GROUP	MODEL
ELE	2018-2022MY Stinger (CK)
NUMBER	DATE
255	June 2022

## TECHNICAL SERVICE BULLETIN

**SUBJECT: DYNAMIC BENDING LIGHT DTC B232509/B232609 - MOISTURE ABSORBENT & BRACKET REPLACEMENT**

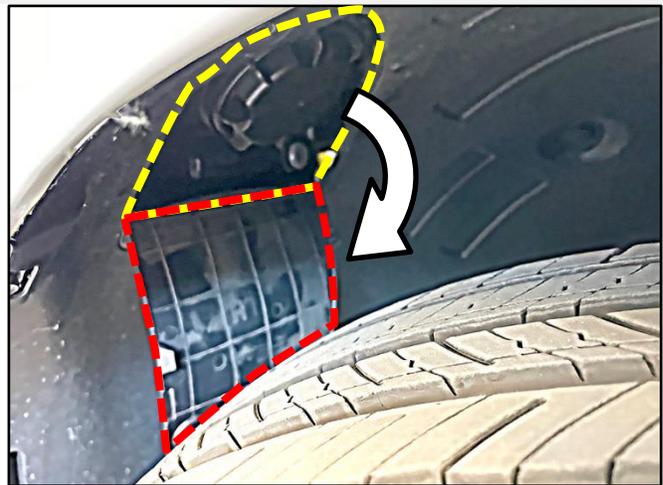
**Note:** The service cover is located on the inner fender liner. Remove the clip at the top of the cover, then fold down as shown to access the dust cover.

Do **NOT** remove the rivets at the bottom of the service cover.

1. Replace the moisture absorbent and bracket on both sides with the new parts by referring to the “Body Electrical System → Lighting System → Headlamps → Repair procedures → Replacement → Moisture Absorbent” chapter in the applicable Shop Manual on KGIS.
